Subject: Genesis Bill Dispenser/Recycler Latch Pin

Overview

BDU-BRU Release Latch Repair Kit

This is document number D900000501, Version 1.2.

Bill Dispenser/Recycler Catch Alignment Procedure

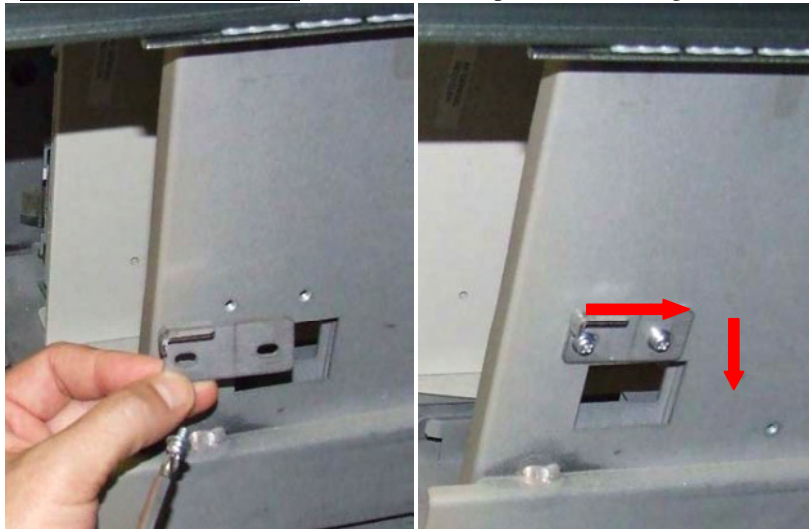
1. Remove the 2 screws retaining the Catch and put a drop of Loctite 242 (part number 11002388, or locally purchased) to the screws and loosely reinstall.
2. Push the Catch as **far down and to the rear** of the Genesis as possible and snug the screws.

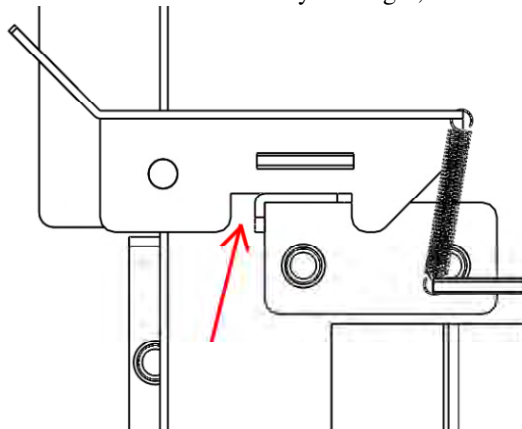
3. The red arrow below indicates the gap that should exist between the Lever and the Catch when the tray is fully racked into the Genesis. This is best verified from the front with your finger, since a visual inspection cannot easily be done.

4. Tighten both Catch securing screws. – Done.
